Envelope and Endcap Update

ePIC Envelopes Update - 03-03-2025 Since 04-17-2024

Cradle Barrel

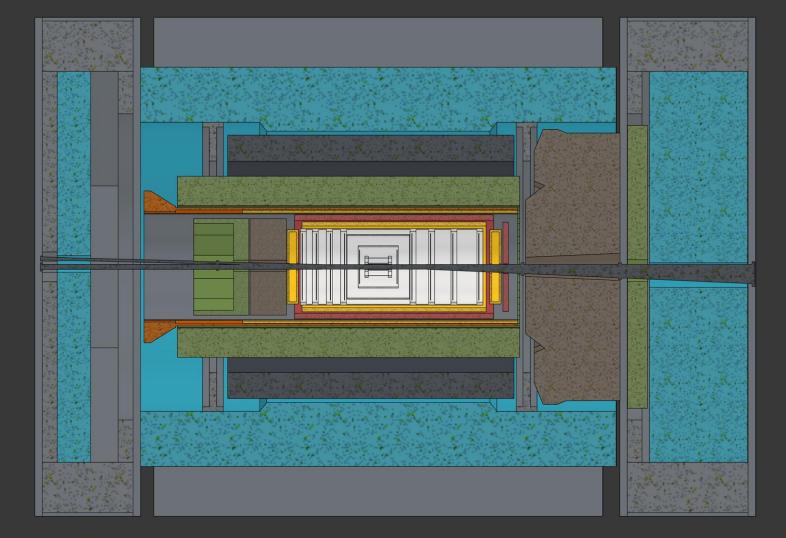
o Removed flux return, complete redesign

Platforms

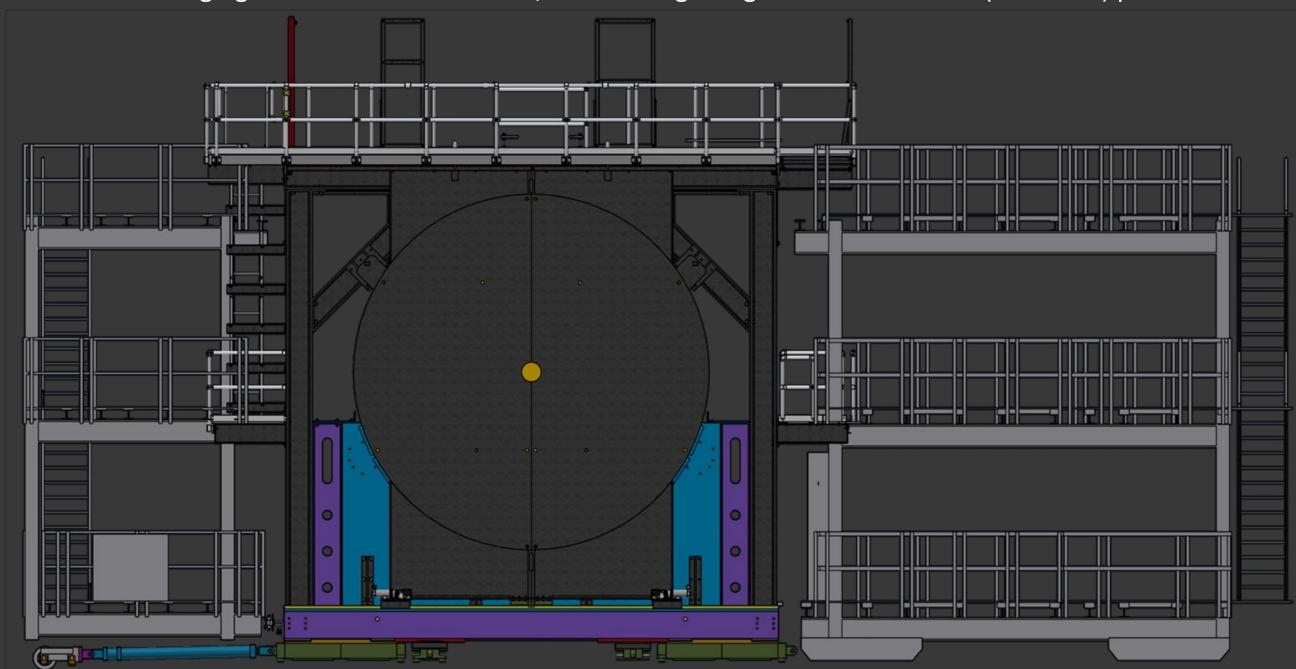
Cradle changing to be more like sPHENIX, Considering using STAR and sPHENIX (~100tons) platforms

Endcap

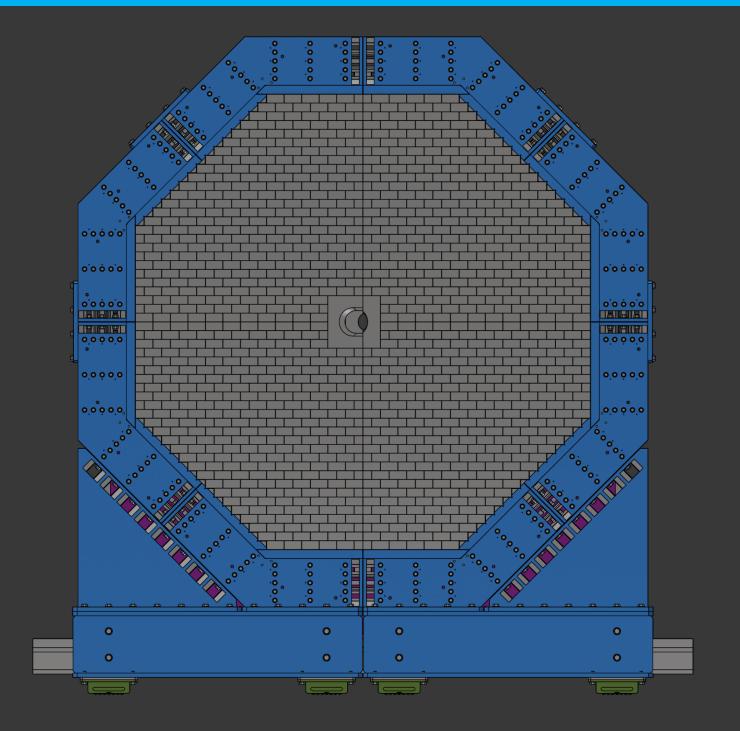
- Adjusted to accommodate 101mm pitch vertically and 202mm pitch horizontally for HCal
- Adjusted to accommodate 101mm pitch vertically and horizontally for EMCal
- Will need to procure base separately for custom Hilman Rollers
